STREET PLAN & PROFILE  
Curb grade revisions - Olivewood Ave. & Panorama Rd. curb return CHRISTENSEN SUBDIVISION  
HORIZ. SCALE 1" = 40' VERT. SCALE 1" = 4'

CITY OF RIVERSIDE, CALIFORNIA  
 DEPARTMENT OF PUBLIC WORKS  
 STREET PLAN & PROFILE  
 CHRISTENGEN SUBDIVISION  
 PANORAMA RD.

**CITY OF RIVERSIDE, CALIFORNIA**  
 DEPARTMENT OF PUBLIC WORKS  
 STREET PLANS & PROFILES  
 CHRISTENSEN SUBDIVISION  
**OLIVEWOOD AVE**

**PROFILE DETAIL**  
OLIVEWOOD AVENUE  
Sta. 11125 to 11205

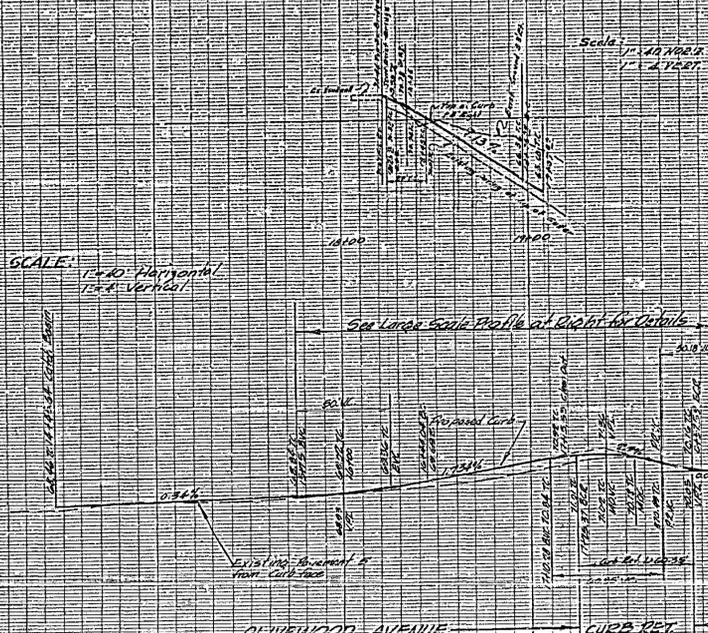
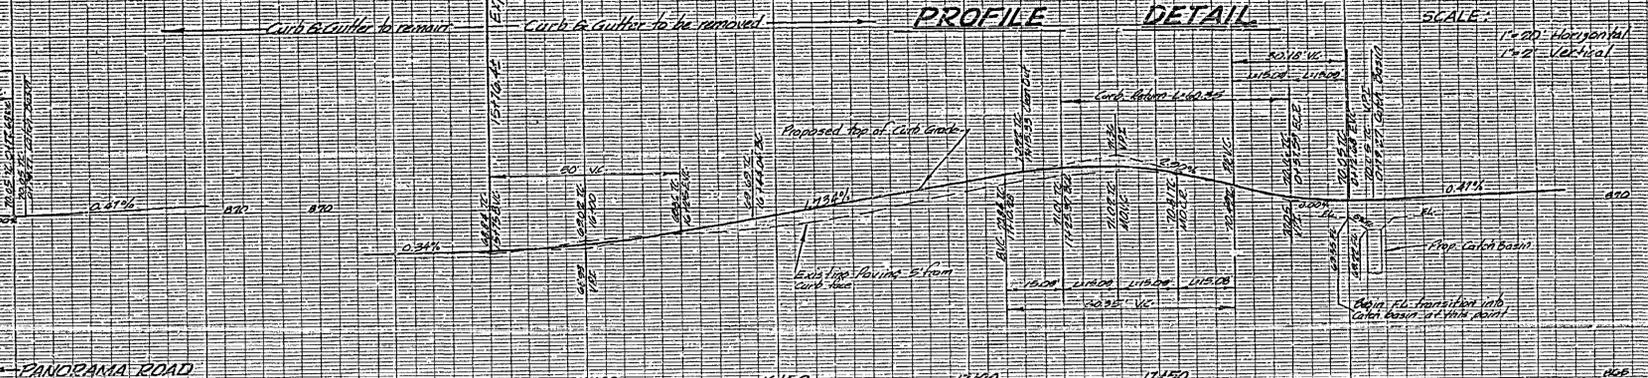
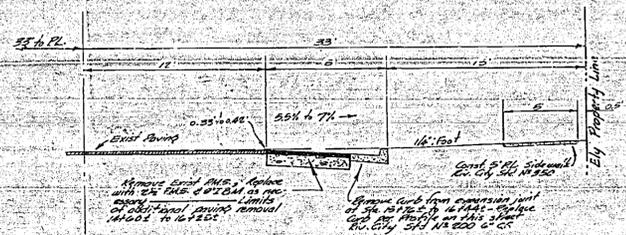
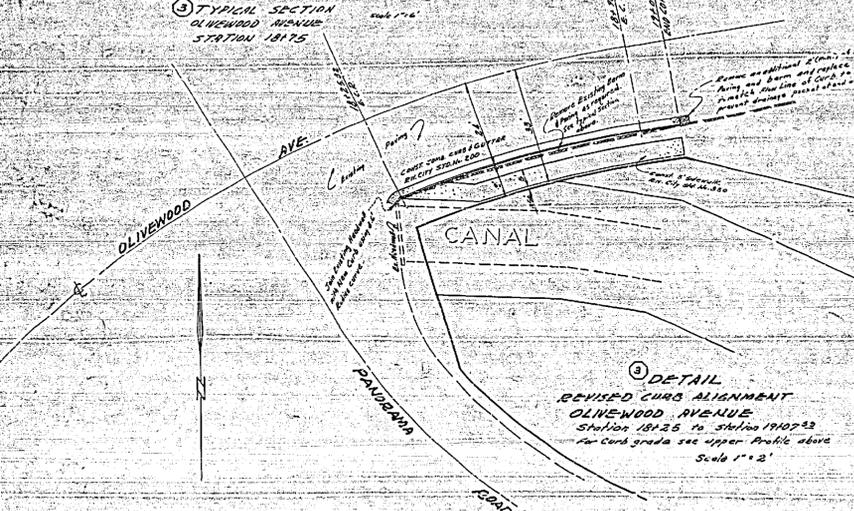
NOTE: This sheet shows revised profiles previously shown on sheets 1 & 2, now marked ② & ③

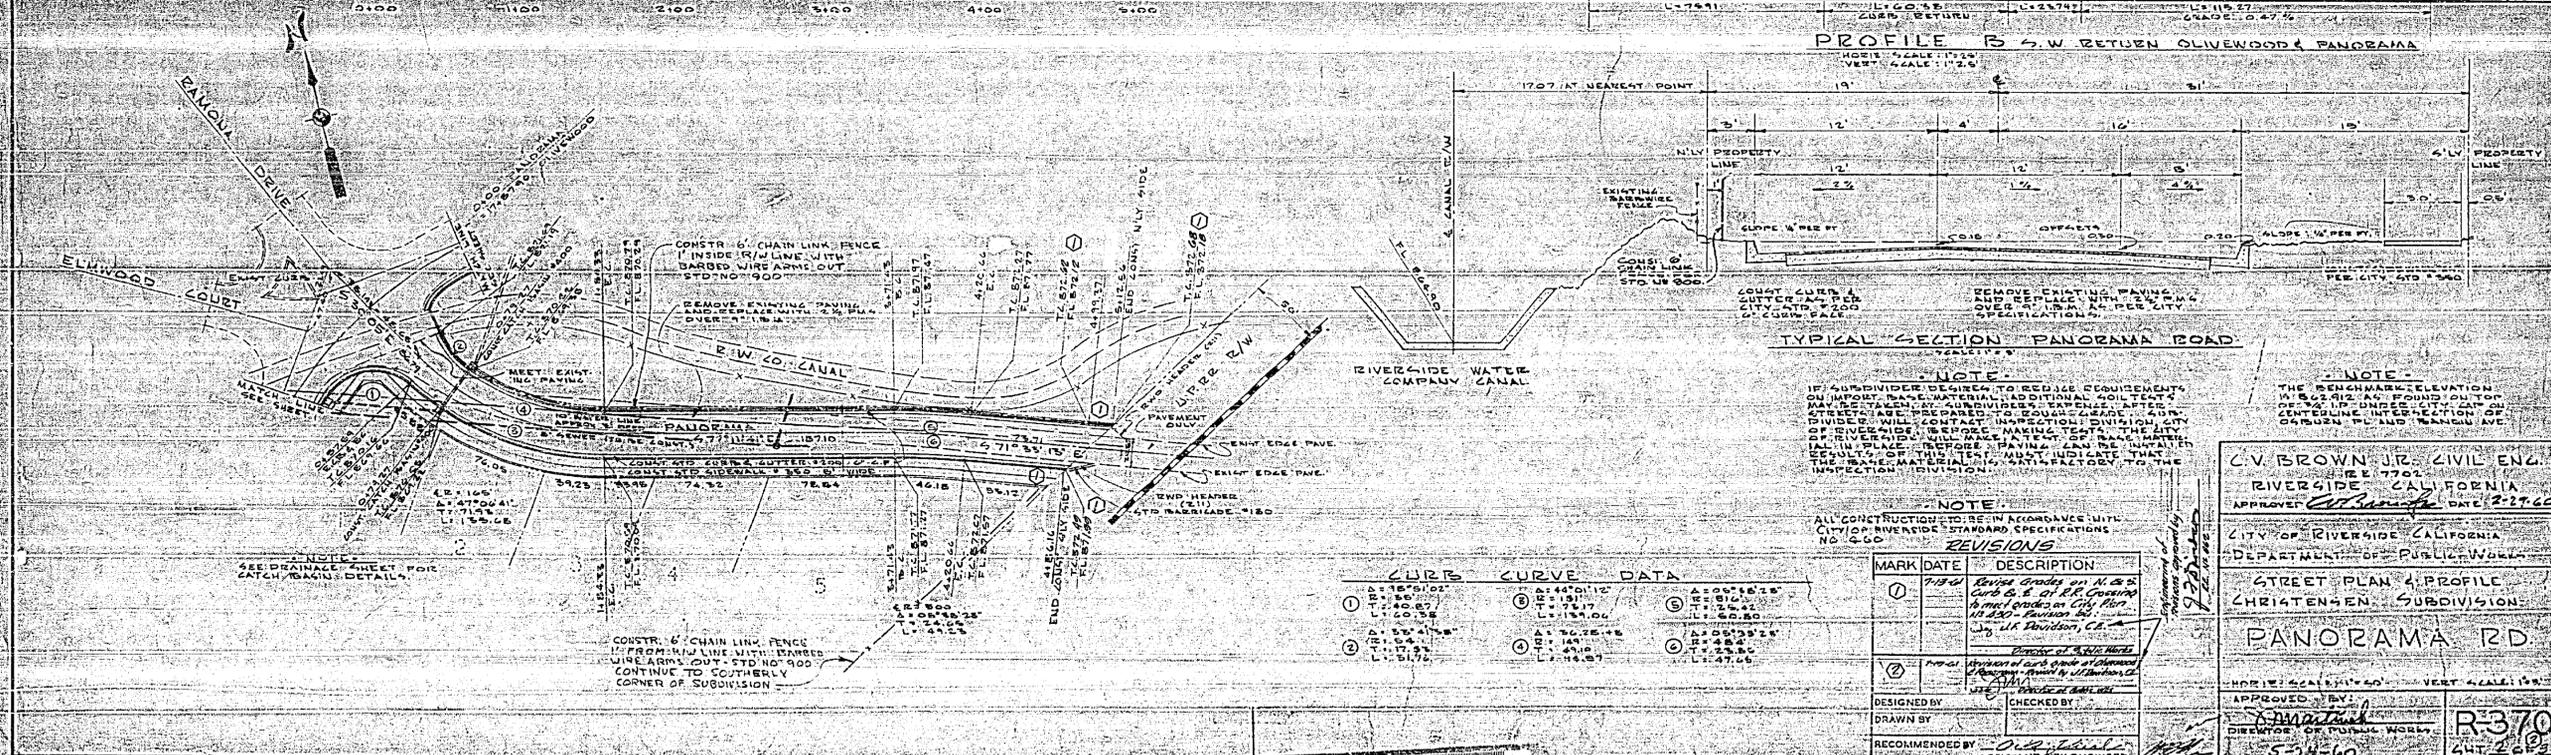
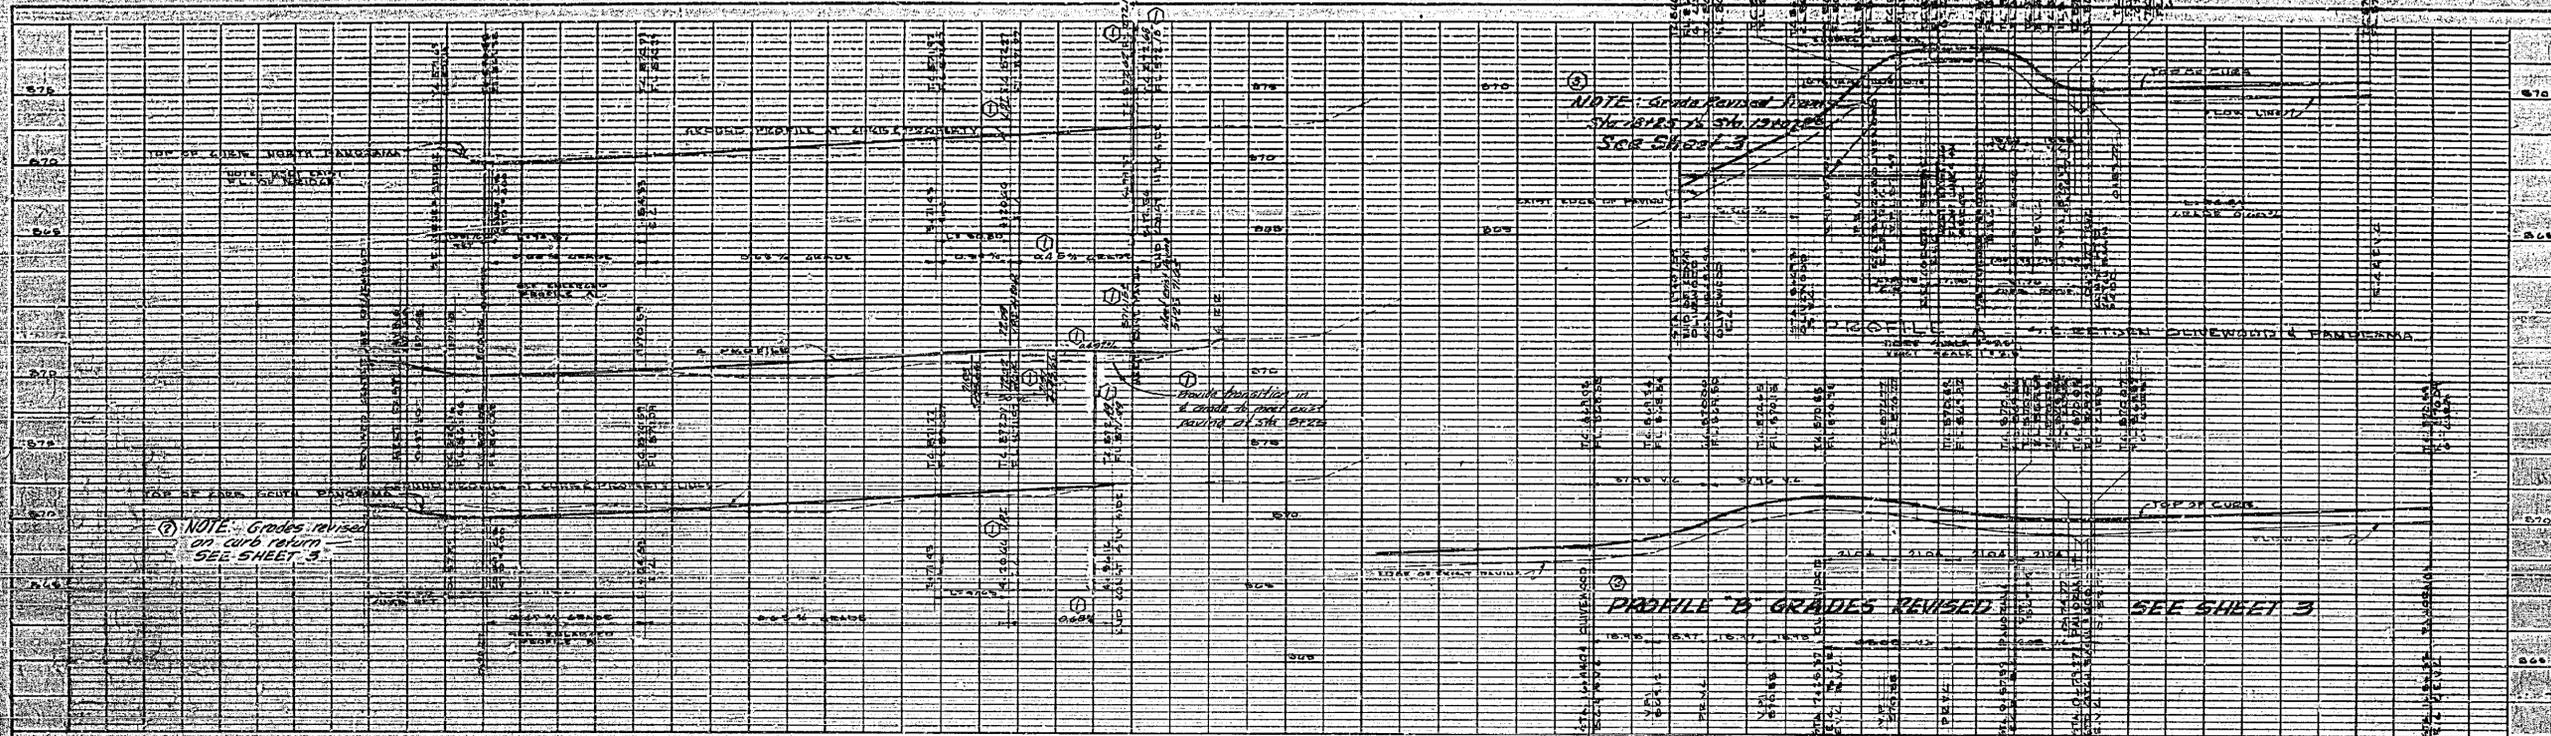
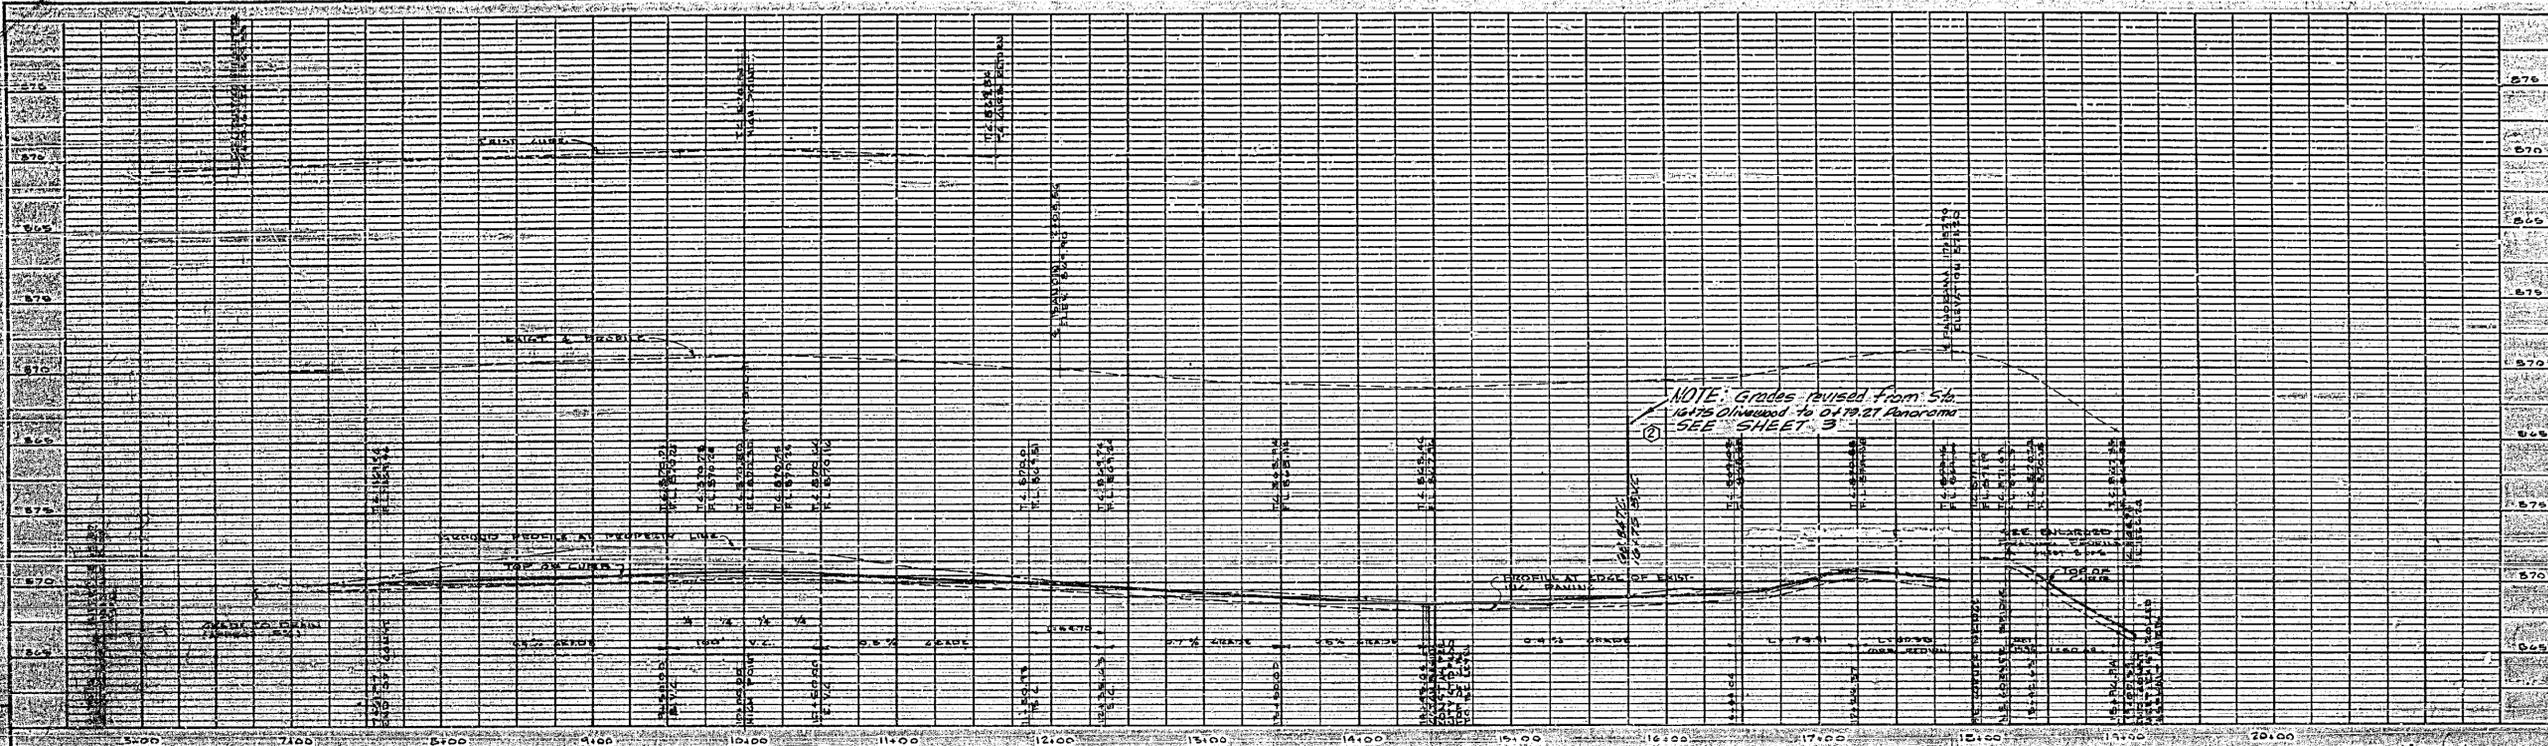
MARK	DATE	DESCRIPTION
1	7/15/60	Grades Revised on A.C.S. Curbs E. of R.R. Crossing to meet grades on City Plan 1/2" = 100' - 5/24/60
2	7/15/60	Grades Revised on City Plan 1/2" = 100' - 5/24/60

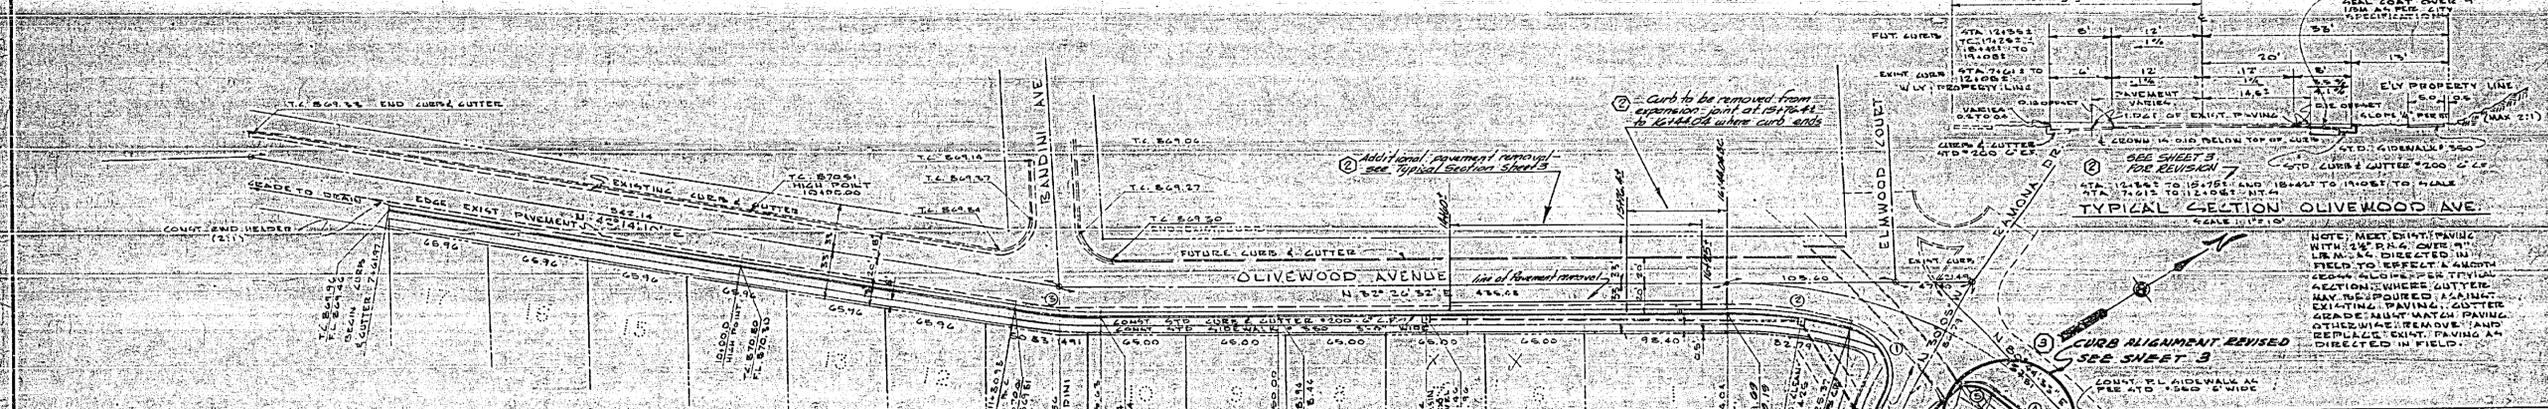
NOTE: Grades revised from 5% to 4% on Olivewood to 0479.27 Kenorima SEE SHEET 3

NO.	DATE	DESCRIPTION
1	11-15-50	Revision of curb grade of Olivewood and Kenorima St. Checked by: [Signature]
